Form 3160-5 (June 2019)	UNITED STATES DEPARTMENT OF THE INTERIOR BUREAU OF LAND MANAGEMENT	FORM APPROVED OMB No. 1004-0137 Expires: October 31, 2021
SUNDRY NOTICES AND REPORTS ON WELLS <i>Do not use this form for proposals to drill or to re-enter an abandoned well. Use Form 3160-3 (APD) for such proposals.</i>		5. Lease Serial No. NMNM19858
		6. If Indian, Allottee or Tribe Name

EOG respectfully requests an amendment to our approved APD for this well to reflect the following changes:

Hawk 35 Fed 103H (FKA 307H) API #: 30-025-48088

Revised Permit Information 09/22/2023:

Revised Wellbore B:

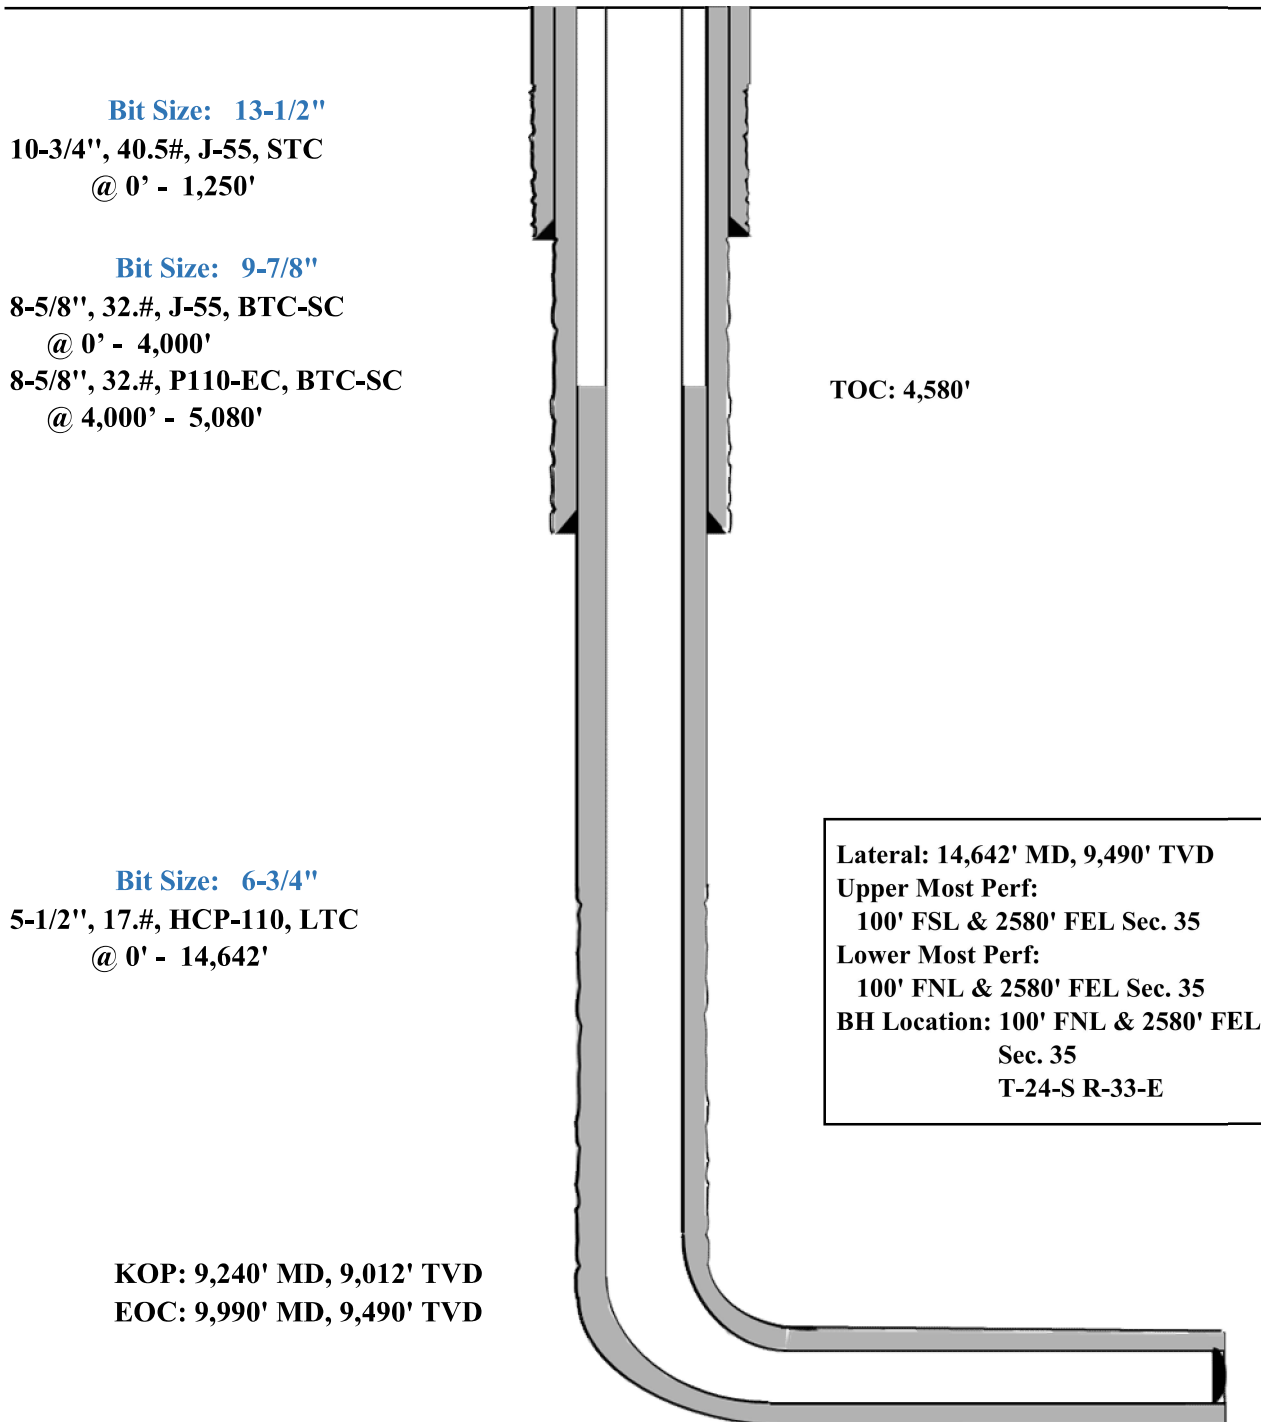
Casing Program B:

Variance is requested to waive the centralizer requirements for the 8-5/8" casing in the 9-7/8" hole size. An expansion additive will be utilized, in the cement slurry, for the entire length of the 9-7/8" hole interval to maximize cement bond and zonal isolation.

EOG requests permission to allow deviation from the 0.422" annulus clearance requirement for the intermediate (salt) section from Onshore Order #2 under the following conditions:

Current Design (Salt Strings)

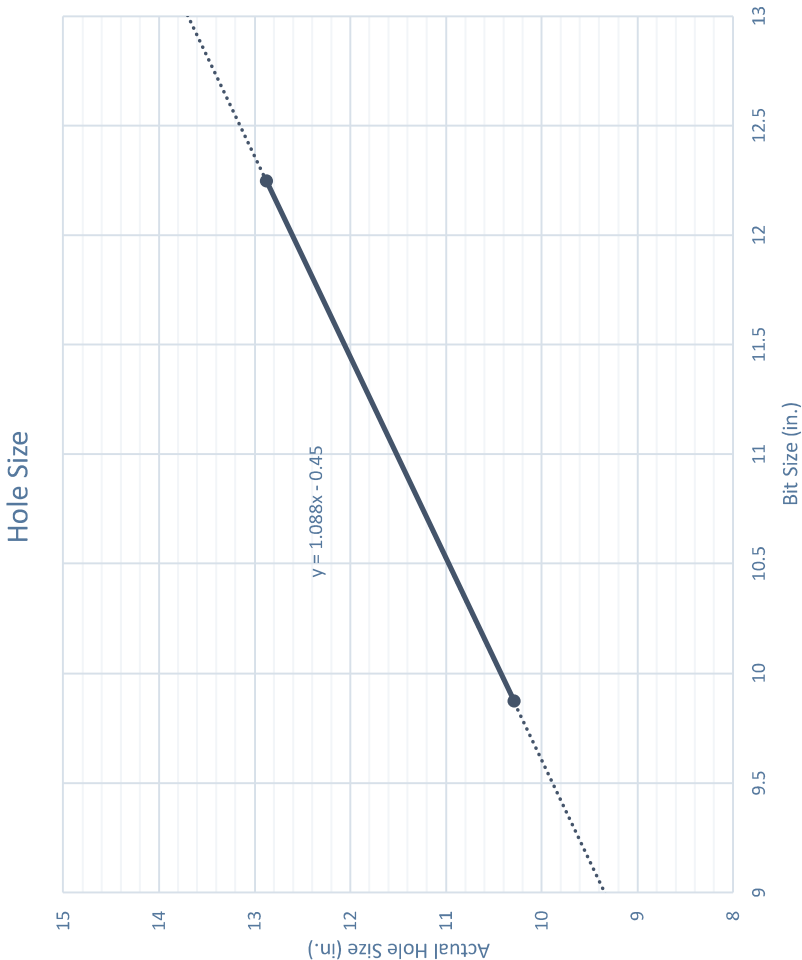
0.422" Annular clearance requirement

- Casing collars shall have a minimum clearance of 0.422 inches on all sides in the hole/casing annulus, with recognition that variances can be granted for justified exceptions.

- 12.25" Hole x 9.625" 40# J55/HCK55 LTC Casing
 - 1.3125" Clearance to casing OD
 - 0.8125" Clearance to coupling OD
- 9.875" Hole x 8.75" 38.5# P110 Sprint-SF Casing
 - 0.5625" Clearance to casing OD
 - 0.433" Clearance to coupling OD

EOG request permission to allow deviation from the 0.422" annulus clearance requirement for the intermediate (salt) section from Onshore Order #2 under the following conditions:

Design A

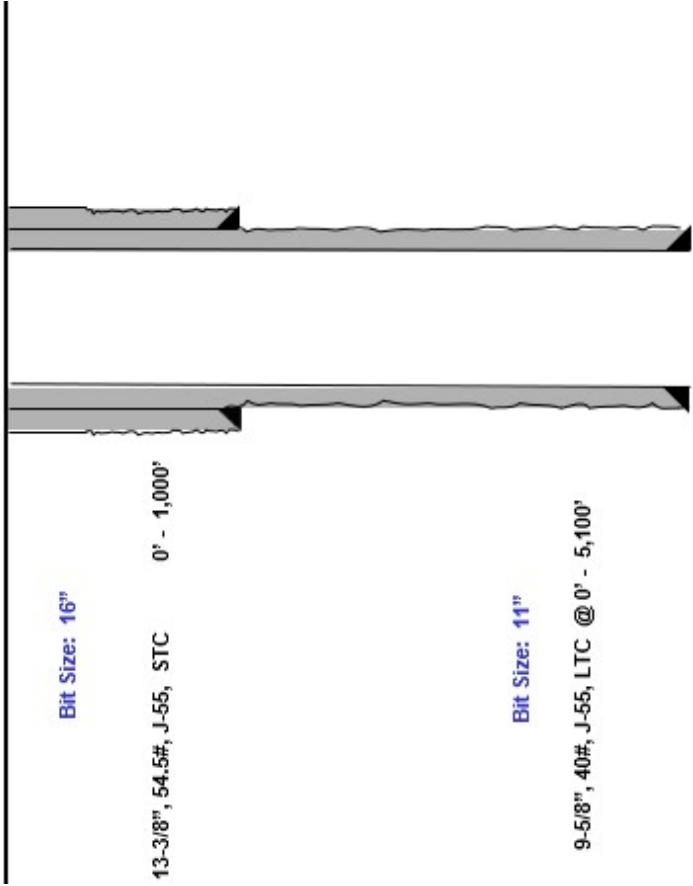
Proposed 11" Hole with 9.625" 40# J55/HCK55 LTC Casing

- 11" Bit + 0.52" Average hole enlargement = 11.52" Hole Size
 - 0.9475" Clearance to casing OD
$$= \frac{11.52 - 9.625}{2}$$
 - 0.4475" Clearance to coupling OD
$$= \frac{11.52 - 10.625}{2}$$
- Previous Shoe – 13.375" 54.5# J55 STC
 - 0.995" Clearance to coupling OD (~1,200' overlap)
$$= \frac{12.615 - 10.625}{2}$$

Design B

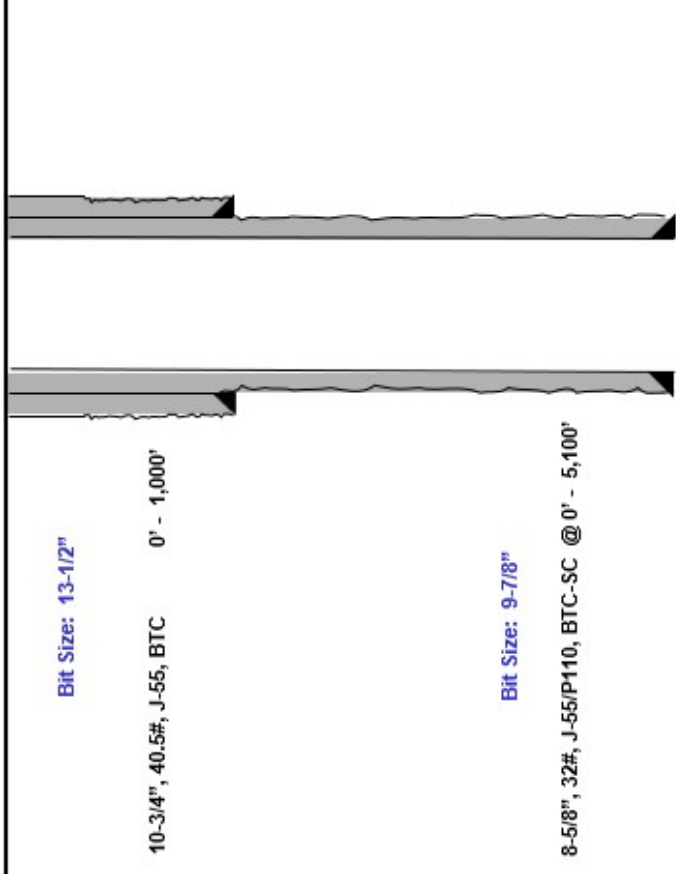
Proposed 9.875" Hole with 8.625" 32# J55/P110 BTC-SC Casing

- 9.875" Bit + 0.42" Average hole enlargement = 10.295" Hole Size
 - 0.835" Clearance to casing OD
$$= \frac{10.295 - 8.625}{2}$$
 - 0.585" Clearance to coupling OD
$$= \frac{10.295 - 9.125}{2}$$
- Previous Shoe – 10.75" 40.5# J55 STC
 - 0.4625" Clearance to coupling OD (~1,200' overlap)
$$= \frac{10.05 - 9.125}{2}$$
